Connector Cover Shape Change for the Mitsubishi MR-J4-B-RJ/RU/KJ/LL Series Servo Amplifier

Date of issue June 2014	Title Connector Cover Shape Change for the Mitsubishi MR-J4- <u>B</u> -RJ/RU/KJ/LL Series Servo Amplifier	Mitsubishi Electric Corp., Nagoya Works 5-1-14 Yada-minami, Higashi-ku, Nagoya 461-8670 Tel.: +81 (52) 721-2111 Main line
-----------------------------------	---	---

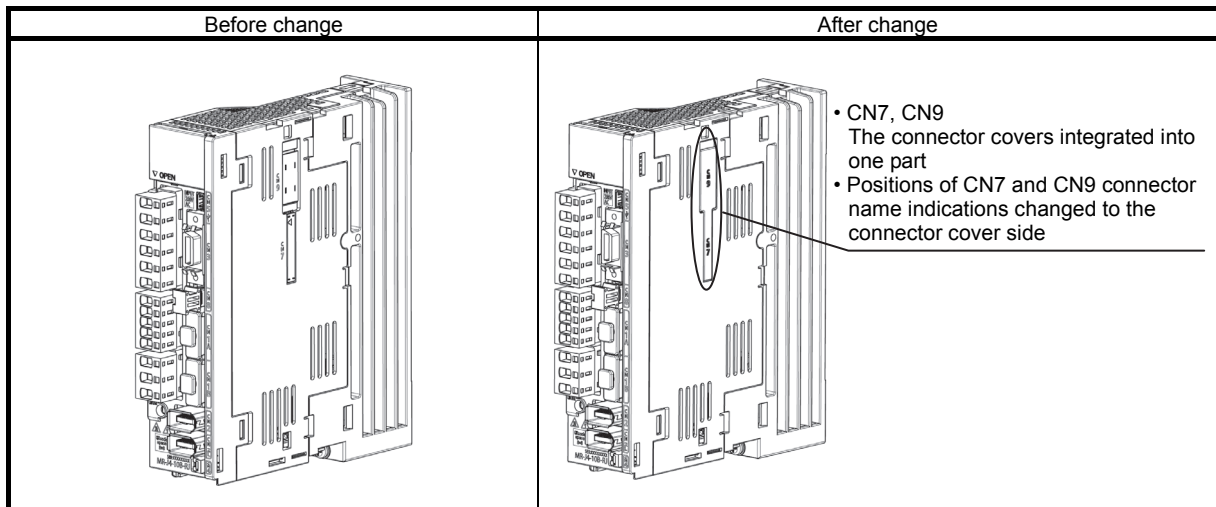
We will integrate the covers for the CN7 and CN9 connectors for option unit connection at the side of the servo amplifier as follows. Also, positions of the CN7 and CN9 connector name indications will be changed to the connector cover side.

Note. The drawing above shows the 100 W model.
